**EDINBURG NOTICE AND AGENDA  
PLANNING AND ZONING COMMISSION  
CITY OF EDINBURG, HIDALGO COUNTY, TEXAS**

**Location:** City of Edinburg  
City Hall-Council Chambers  
415 West University Dr.  
Edinburg, Texas 78539

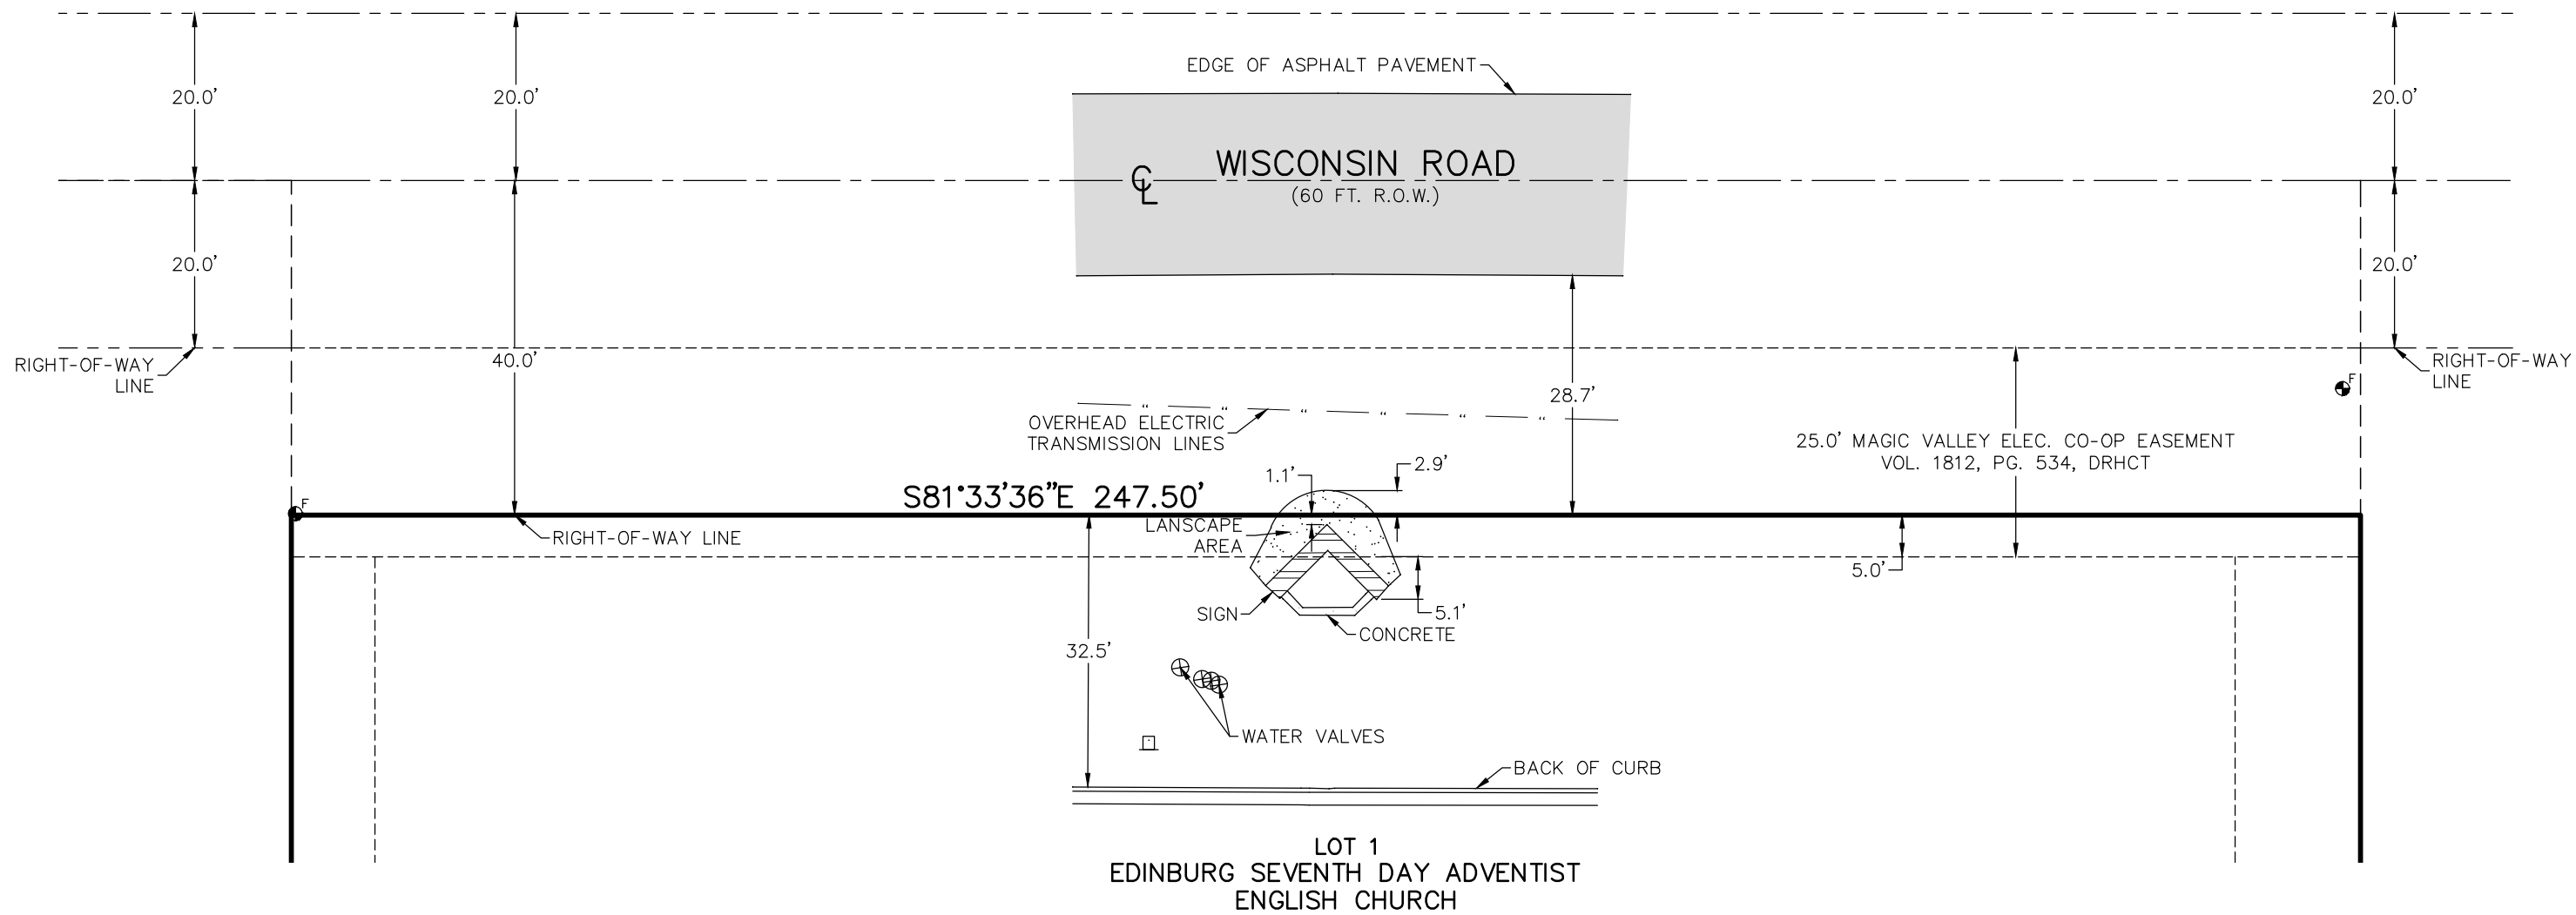
Planning and zoning comments:

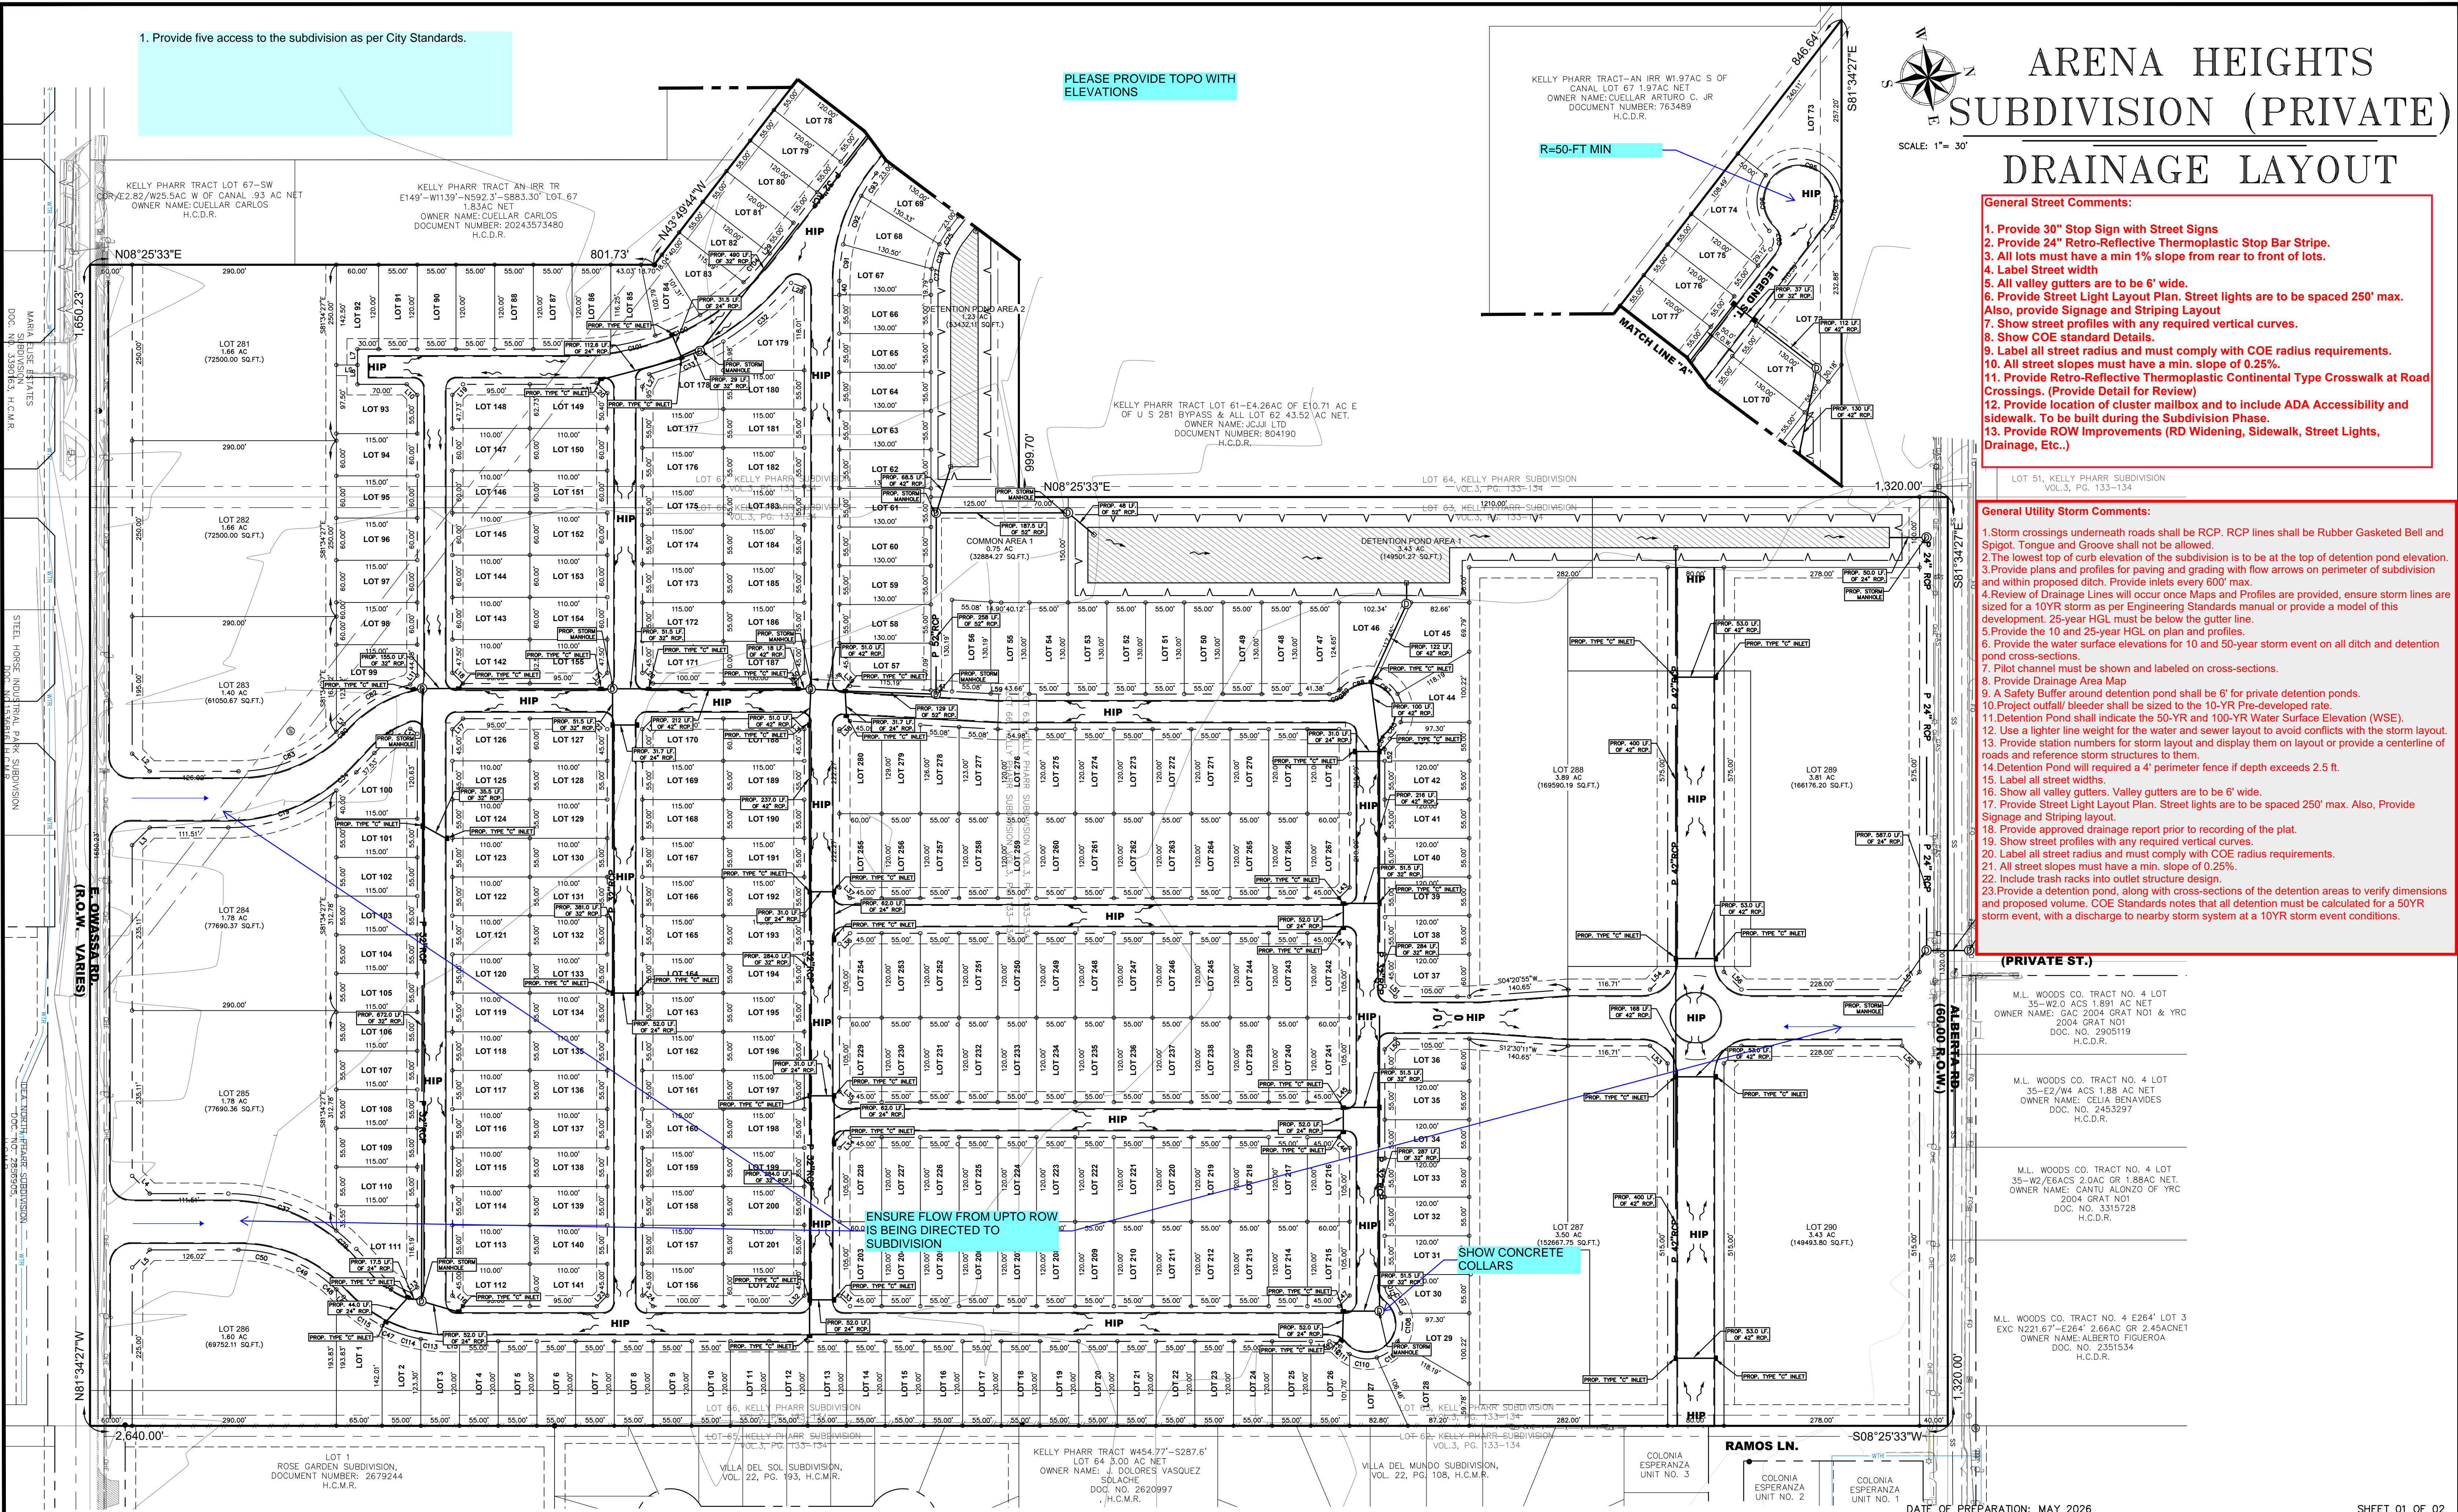
- General Utility Storm Comments:**
1. Storm crossings underneath roads shall be RCP. RCP lines shall be Rubber Gasketed Bell and Spigot. Tongue and Groove shall not be allowed.
